7-G-21-HZ
APPLICATION FOR CERTIFICATE OF APPROPRIATENESS

1017 Thompson Place 37917
Old North Knoxville H

Staff Report

File Number: 7-G-21-HZ

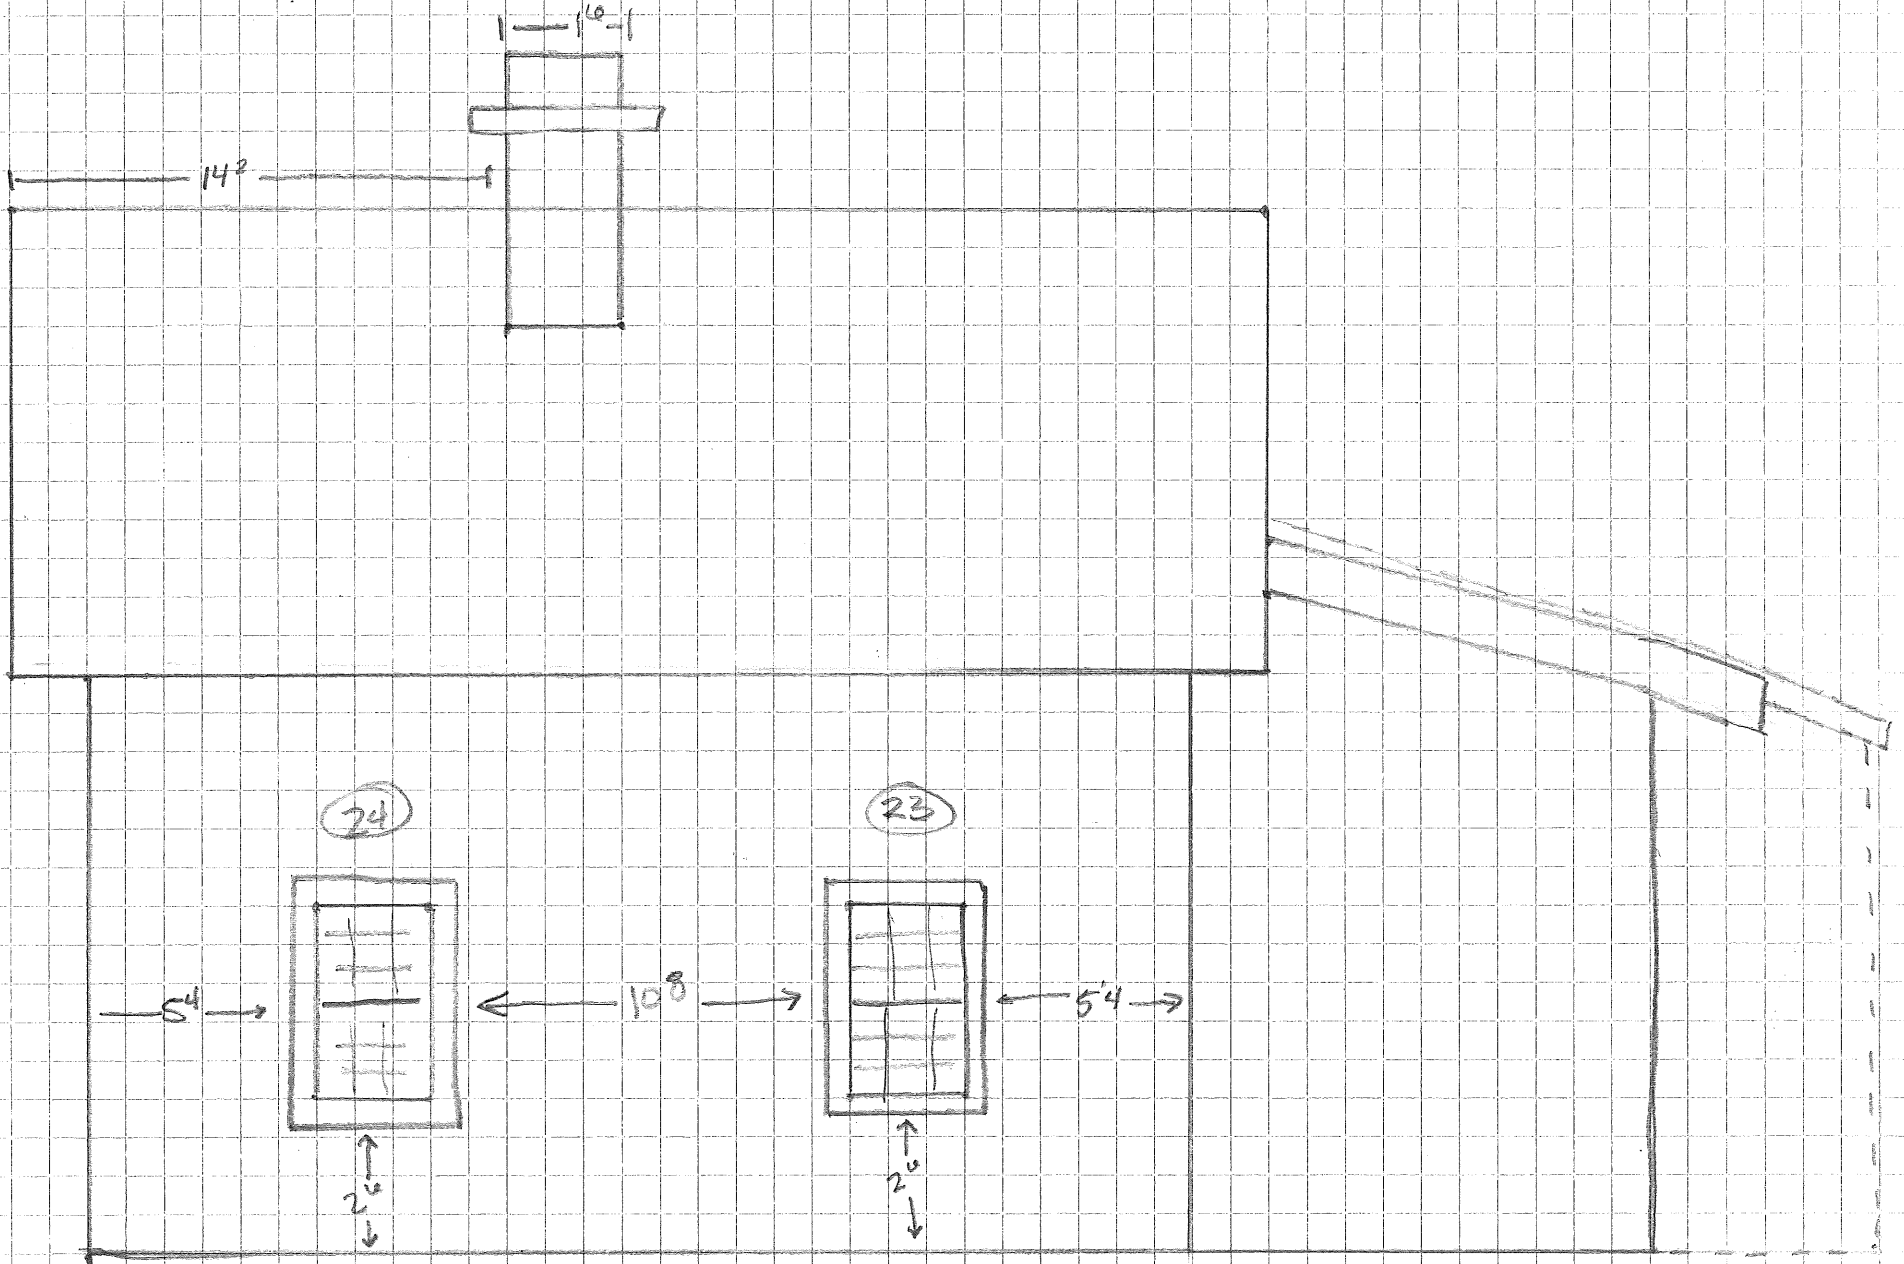
New siding pattern on the second story: applicant requests to install cedar shake/shingle siding on the front and rear gable fields, instead of the wood lap siding. Shingle siding would start immediately below second-story window sills and continue to roofline.

3. The applicant has proposed cedar shakes instead of wood lap siding in the upper-story gable fields due to current cost constraints with wood siding. In "wood wall coverings," guidelines note that "an entire wooden feature that is too deteriorated to repair "shall be replaced in-kind" and be "compatible with the original in size, scale, and material." Guidelines also recommend that replacement parts should be based on historical, pictorial, and physical documentation. There are instances of Craftsman residences with Dutch Colonial influences using shingle siding in Knoxville; however, there is no evidence of shakes or shingles as an original siding element on this house's gable fields.

Request Cedar Shake just under window to roof

WOOD CLAP BOARD SIDING TO MATCH EXISTING SIDING EXPANSURE ON ALL SIDES AS NEEDED

Staff recommends approval of the work as proposed, with the following conditions: 1) omit cedar shakes and use lap siding with an exposure and placement to match existing siding on front and rear gable fields; 2) rear addition to receive siding, cornerboards, window and door trim to match original house; 3) new windows to be installed on rear elevation and rear addition should be compatible with historic windows in materials, size, and design, with final specifications submitted to staff for approval.

Right Elevation
(New Request)

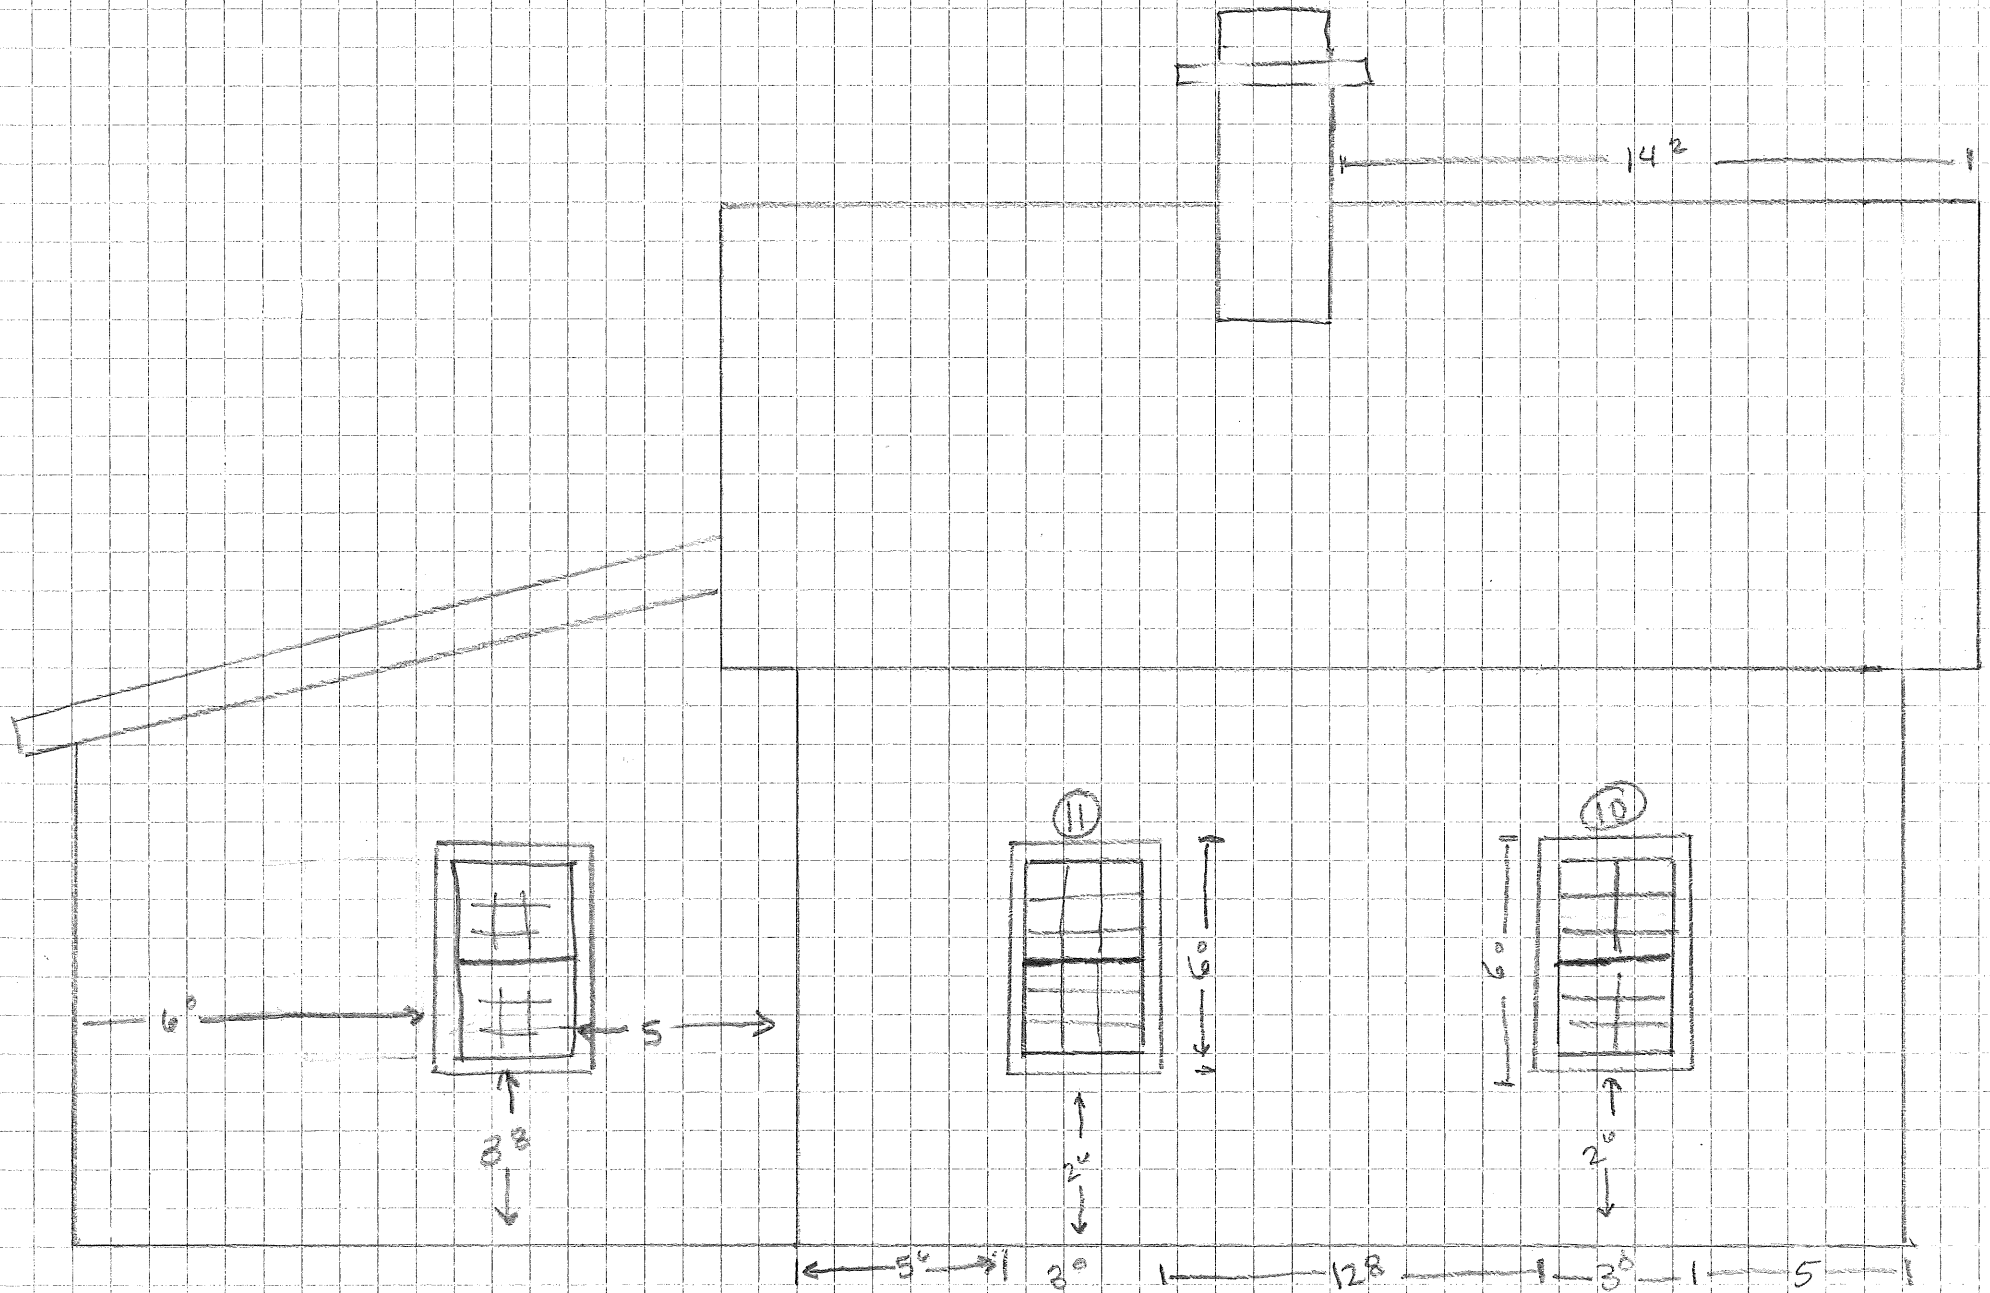
Modified rear elevation and new rear addition: after-the-fact review of new rear addition. Previous rear elevation included a gable-roof rear addition, with a shed-roof section extending towards the east. The applicant removed this rear addition and constructed a continuous shed-roof addition in the same footprint as the previous. The rear elevation will now contain two adjoining windows followed by a secondary entry door recessed on the main massing, with an 8' wide by 15" tall transom window centered on the shed-roof addition.

4. The new rear addition was built within the same footprint of the previous rear addition. The rear addition is slightly inset from the main house (~6 inches) and is minimally visible from Thompson Place. While the shed roof on the addition is somewhat large in massing, the previous addition featured a combination gable and shed roof which were also not fully compatible in in mass and design.

5. The rear addition should use wood lap siding with a matching exposure, corner boards, and window and door trim to match the main house. As currently built, the foundation's sill plate is resting on the old bricks from the old foundation. The applicant should clarify the foundation finish materials and how it will meet the design guidelines.

Back Elevation

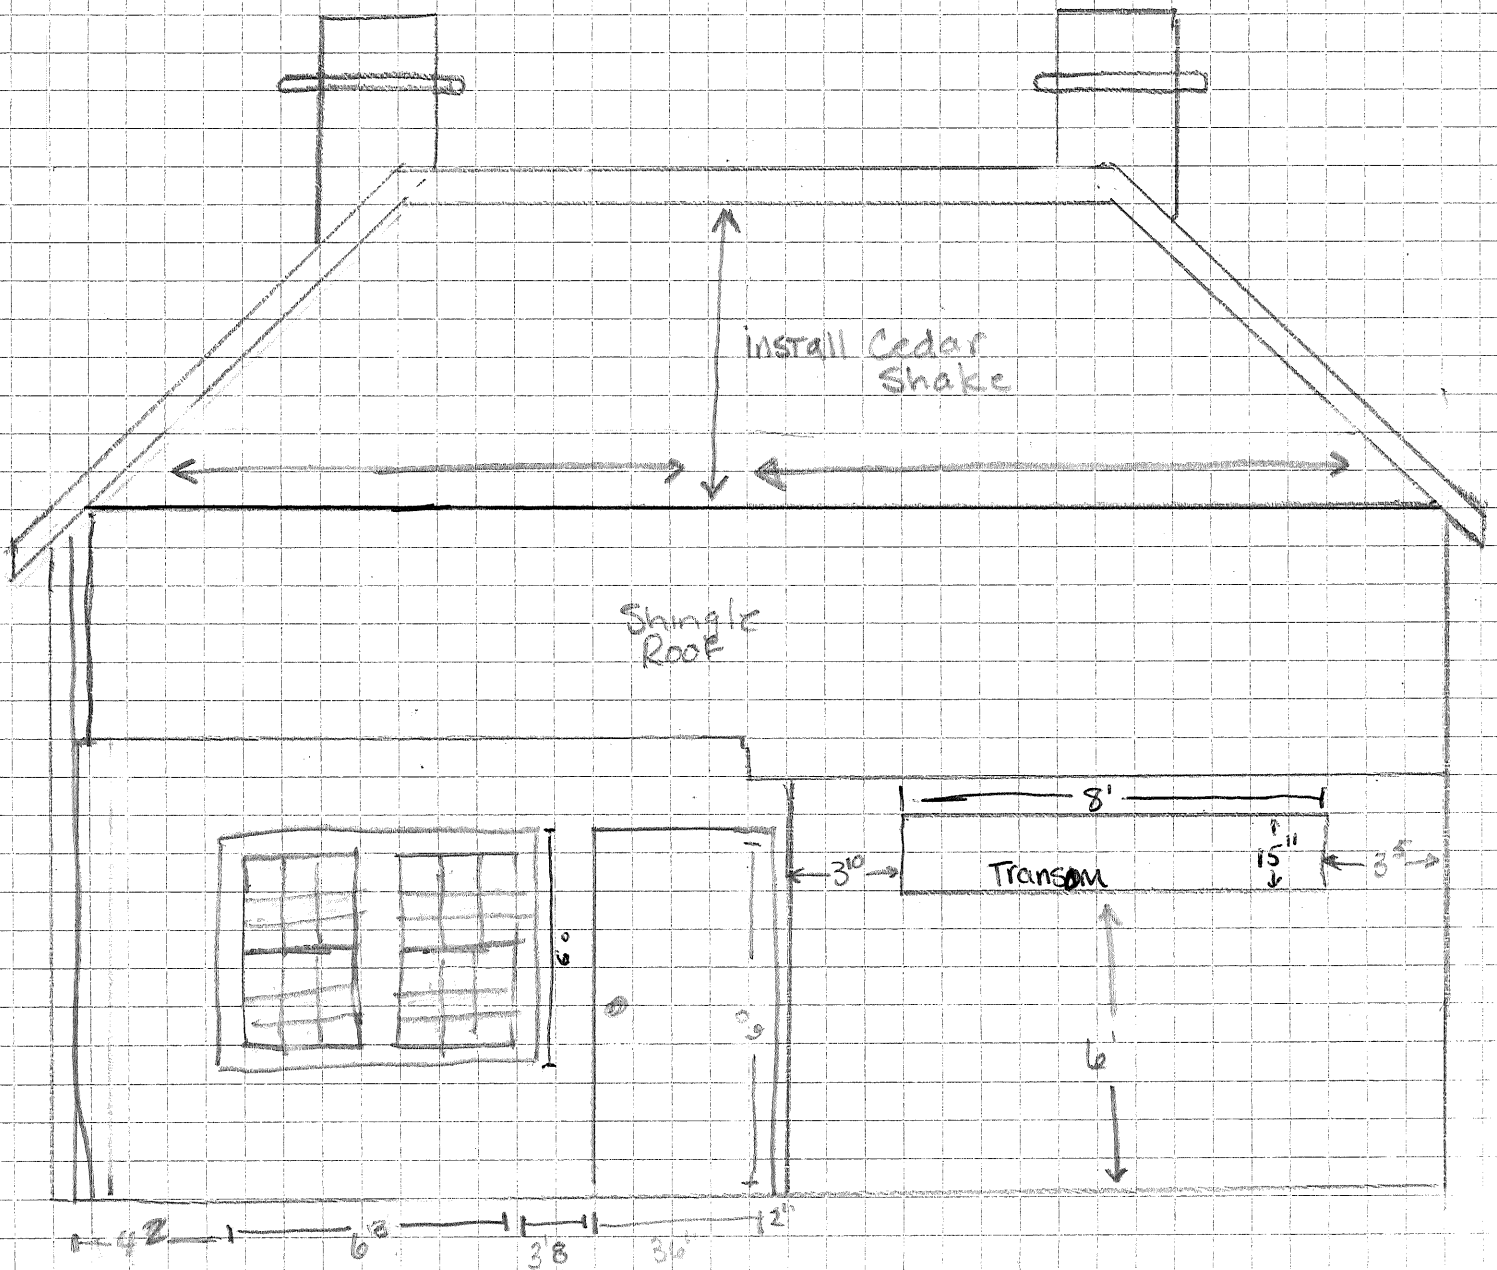
6. New windows installed on rear elevation and rear addition should be compatible with the historic windows in materials, size, and design, with final specifications submitted to staff. The secondary door on the rear elevation should meet design guidelines for secondary entries and be submitted to staff.

Request Cedar Shake From
Bottom Roofline to Top of
Roof
